# Lawrence Livermore National Laboratory

December 26, 1996  
NTFS96-516

### Responses to Priority Questions for LLNL

We have a number of questions about the NRC licensing test procedures and about the NRC sponsored report **Shipping Container Response to Severe Highway and Railway Accident Conditions** by Lawrence Livermore National Laboratory (LLNL). Some questions may be addressed by anyone knowledgeable of cask testing and design; while LLNL may have to clarify others.

Figure 4-2 Schematic representation of cask structural response for various surface hardness and impact velocities.

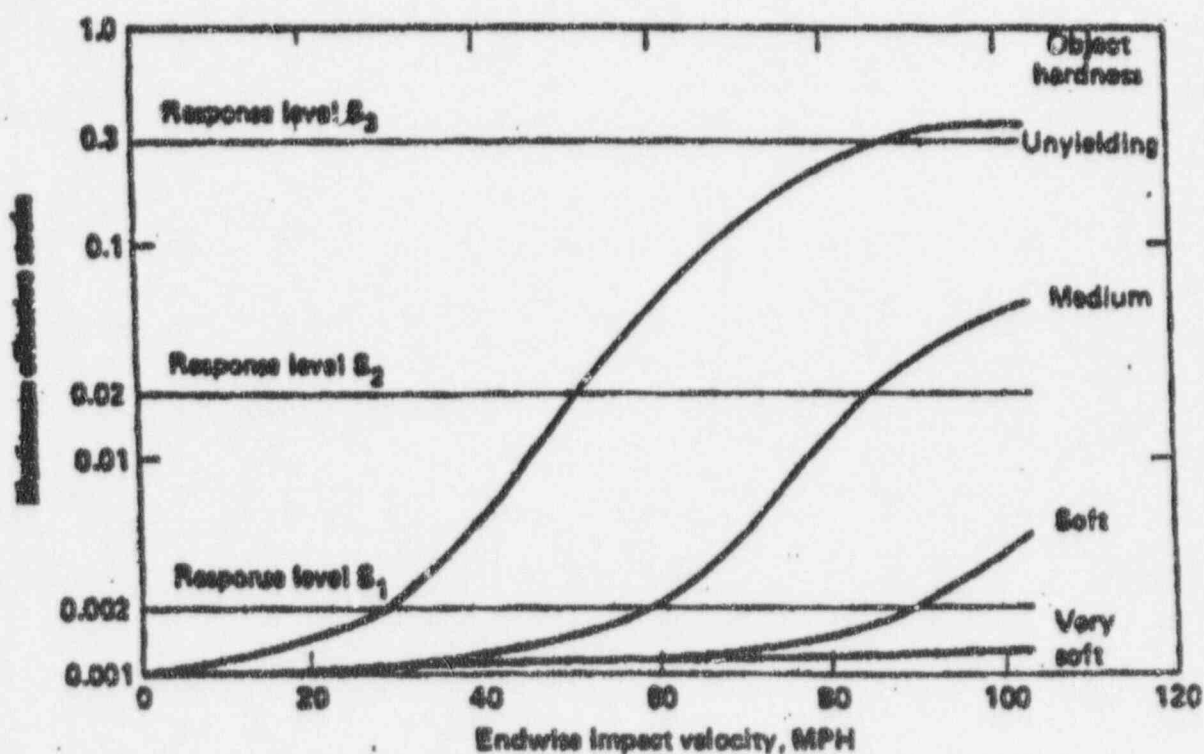
- E. If one wished to estimate the influence of surface hardness, one could use Figure 4.2. Please confirm our interpretation of this Figure indicating that: going from an unyielding to medium surface hardness leads to a 1.8 (~ 82 / 45 mph) increase in impact speed to attain the S2 response level (i.e. 0.02 strain). Thus, the impact described in III above would have to occur at  $1.8 * 47 = 85$  mph which in turn is associated with a cask speed of  $84.6 / \sin 45 = 120$  mph.

- A. Your interpretation of Figure 5.1 is correct.
- B. Your conclusions based on the interpretation are correct. We suggest that for truck accidents you use Figures 2-3 and 2-4 with Table 5.9 to obtain probabilities and damage state information where the interpretations and conclusions have already been made and tabulated. For rail accidents use Figure 2-5 in conjunction with Table 5.11.
- C. Please see response B.
- D. Your interpretation is correct.
- E. Please see response B.

Figure 5-1 Effect of cask orientation on the strain-impact velocity relationship for a truck cask impacting an unyielding object.

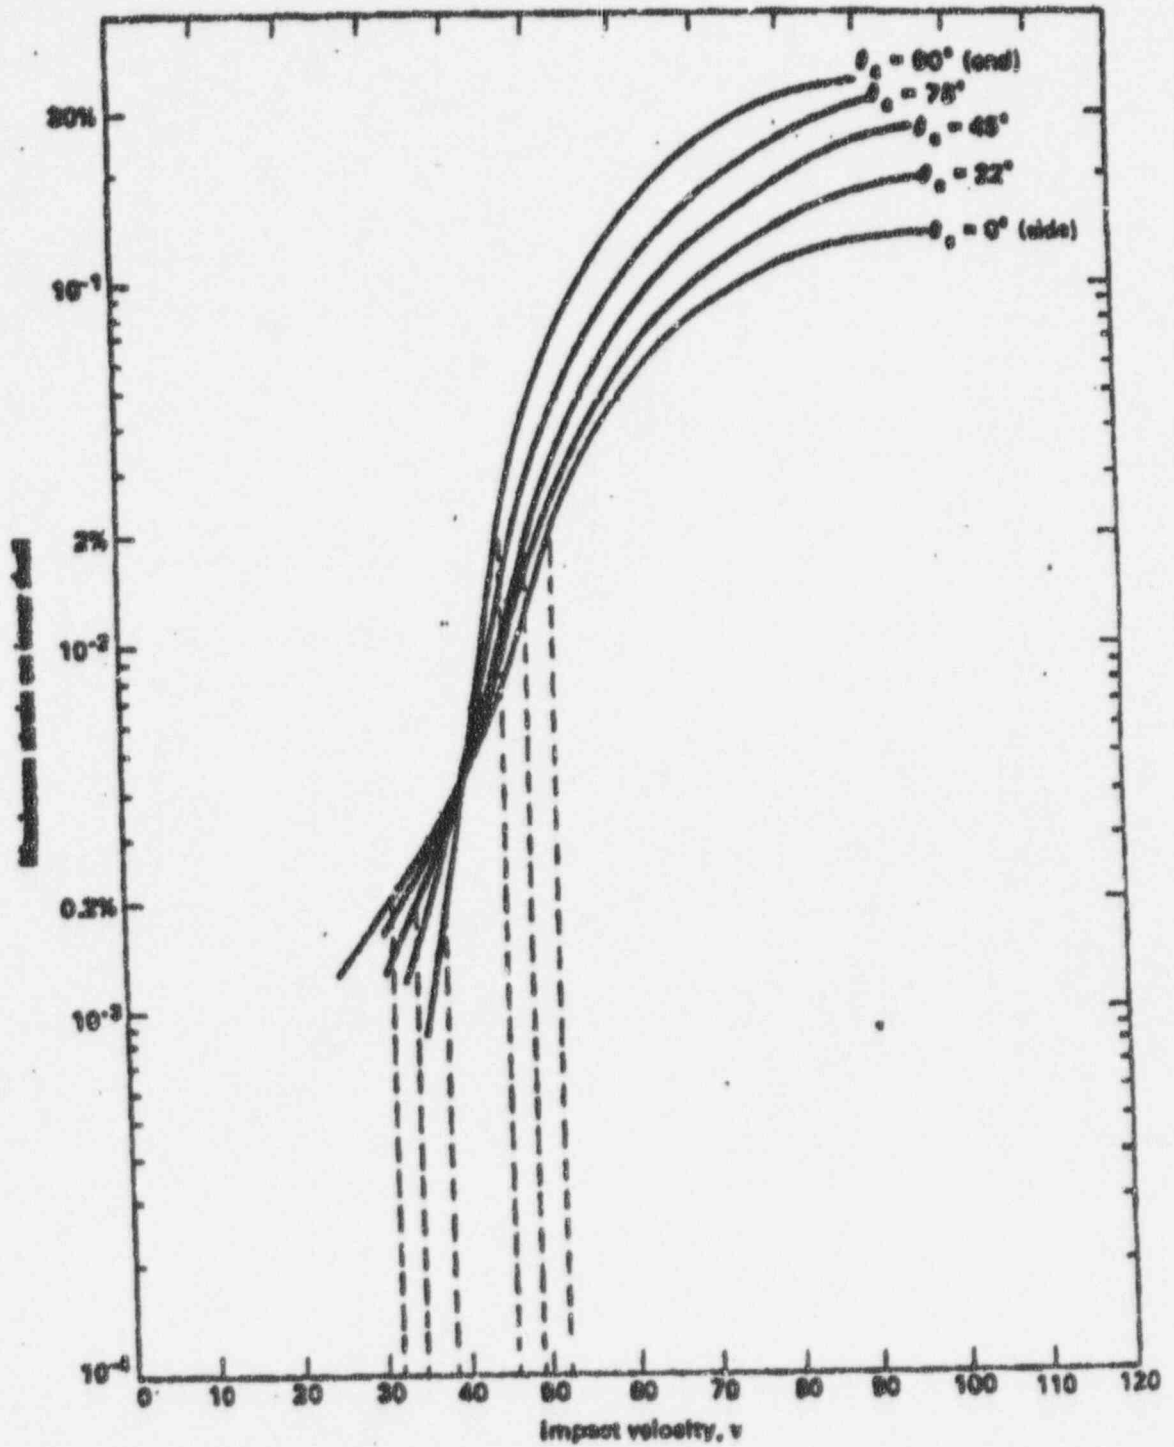
We have data interpretation questions related to Figure 5.1 of LLNL's report. There is quite a bit of information presented in the cask orientation curves drawn there. Others have made a different interpretation of the data than we have and we would like to have our logic reviewed. We would like to have LLNL either confirm that our interpretation of the Figure is correct or provide the proper interpretation. We have provided a copy of the original figures for easy reference.

- A. Please indicate whether the following interpretation of the Figure content is correct:
1. The solid curves present a fit of data points such that each solid line locates a conservative estimate of the strain levels experienced for the specified cask orientation under a range of impact speeds.

2. The dashed lines are there simply to highlight the speeds associated with the two identified strain thresholds (i.e. .02% and 2.0%).
  3. Impact velocity refers to the cask's speed-vector component that is perpendicular to the impacted surface.

- B. Using this interpretation, please confirm that a 0.2% strain level is achieved at (roughly):
- 31 mph impact speed for a cask with a 0° (side) orientation;

- 34 mph impact speed if at a 45° orientation; and;
  - 38 mph impact speed if at a 90° (end) orientation.
- Similarly, a 2.0% strain threshold, is reached at:

- 52 mph impact speed for a cask with a 0° (side) orientation;
  - 49 mph impact speed if at a 45° orientation; and;
  - 47 mph impact speed if at a 90° (end) orientation.

- C. Further, if one wished to determine the speed magnitude necessary to reach the 2% strain threshold for a cask at 90 degree orientation, impacting the unyielding surface with a velocity vector angle of 45°, one would select the 47 mph impact speed from the plot and divide by .707 ( $\sin 45^\circ$ ) to derive the cask speed = 66.5 mph.

- D. There was a third threshold level used in the study (30% strain). Please confirm that the Figure offers no basis to estimate the impact speeds necessary to reach that threshold for casks at 45° and 0° orientations; other than that the speeds would be unreasonably high ones.
